1148 Wireless Personal Pendant

Version 106 Software Update

TU-0844 © 2016 Digital Monitoring Products, Inc.

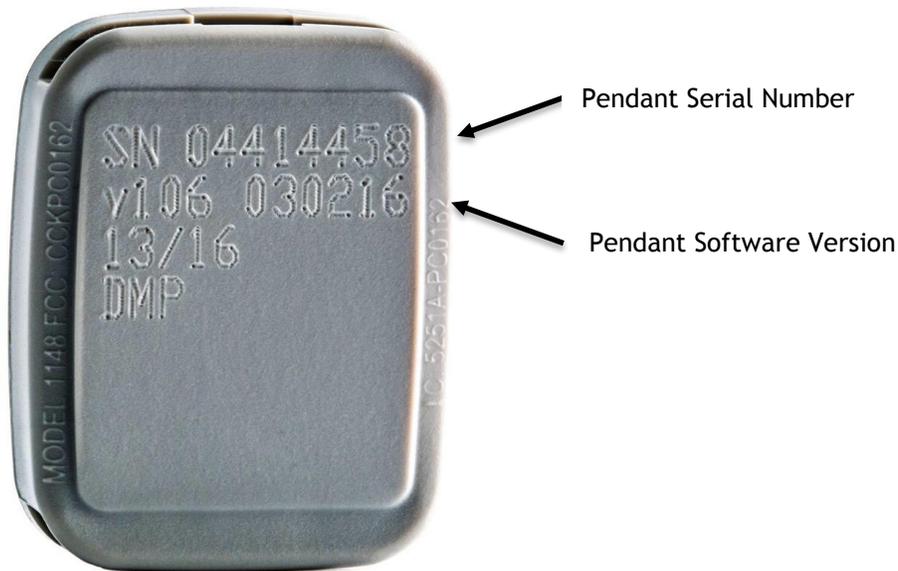
If you choose the Replacement option, Remote Link Version 1.78 (3/25/16) includes a new 1100 Update Reports option to identify all transmitters with 1148 software Version 106 (6/23/15) in the Remote Link database. The 1148 pendants fall within a serial number range beginning with 04368824 to 04414947. Pendants with the new Version 106 (3/2/16) begin with serial number 04421717. The 1148 Pendant serial number range is also shared with the Model 1141 Wall Button and Model 1142 Panic Button transmitters. The Remote Link 1100 Update Report will also include serial numbers for any 1141 and 1142 transmitters you may have installed. The zone name can be used to distinguish between pendants and other transmitters. The 1141 and 1142 transmitters are not affected by update.

- 1) Select File > Print > 1100 Update Reports
- 2) Select the account number range to search or select All Accounts.
- 3) Select the Summary List Report option to display the number of affected transmitters in each selected account.
- 4) Select the Work Sheet Report to view the Zone Number, Zone Name and Serial Number of affected transmitters in each selected account.

The Worksheet Report also includes a New Serial # column to allow the serial number of an updated 1148 to be recorded for the zone number.
